LADD SUBDIVISION, RESUBDIVISION OF AND ADDITION TO LOTS 2 & 3

APPLICATION NUMBER 17 DATE September 15, 2011

REQUEST Subdivision

DETAIL SITE PLAN

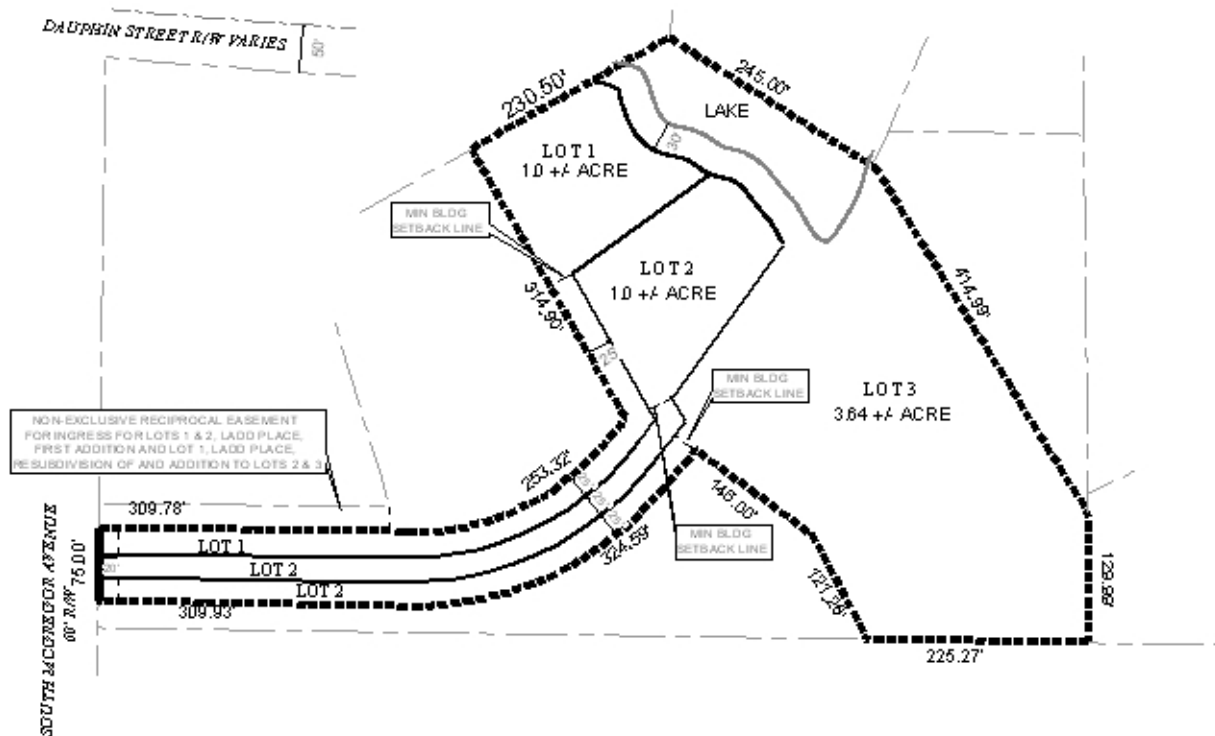
All lots meet the minimum size requirements of the Subdivision Regulations. As on the preliminary plat, the lots should each be labeled with their size in acres on the Final Plat, or a table should be furnished on the Final Plat providing the same information. The plat does not furnish a dimension for the Northern line of Lot 3 on the lake East of the North line of Lot 1. Therefore, the plat should be revised to include this dimension.

As Proposed, Lot 3 would contain a portion of a lake which indicates that the area may be environmentally sensitive; therefore, the approval of all applicable federal, state and local environmental agencies would be required prior to the issuance of any permits or land disturbance activities.

A slight error in the legal description has been found by the department GIS section pertaining to the final direction closing to the Point of Beginning. That direction should be corrected to read "S 89° 38' 42" W 309.93 feet"

- 6) labeling of each lot with its size in acres, or the furnishing of a table on the Final Plat providing the same information;
- 7) revision of the plat to furnish the dimension of the North line of Lot 1 on the lake East of Lot 3;

- 10) correction of the legal description in the final direction closing to the Point of Beginning to read "S 89° 38' 42" W 309.93 feet"; and
- 11) subject to the Engineering comments: *(Detention is needed for any cumulative increase of impervious area added to the areas located within the limits of the subdivision since 1984 in excess of 4,000 square feet. If applicable, need to provide certification that the existing detention system is sized to accommodate the expected increase in impervious area or need to provide additional detention. Must comply with all storm water and flood control ordinances. Any work performed in the right of way will require a right of way permit).*
